# Announcement Product Change Notification SHV Relays

## SHV Relay Series – Change of marking style

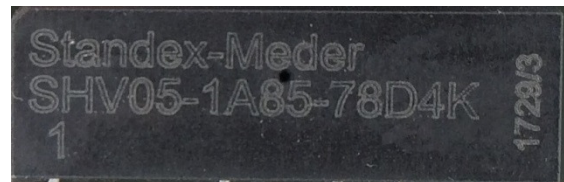
Due to new improvements and in order to increase a production yield and delivery flexibility, the marking style of all SHV Relays will be changed from “ink stamped” to “laser” printing.

This modification will not affect any electrical or mechanical properties of the relay. As well as all relay descriptions and names stay the same.

Old Ink Stamped Marking

New Laser Marking
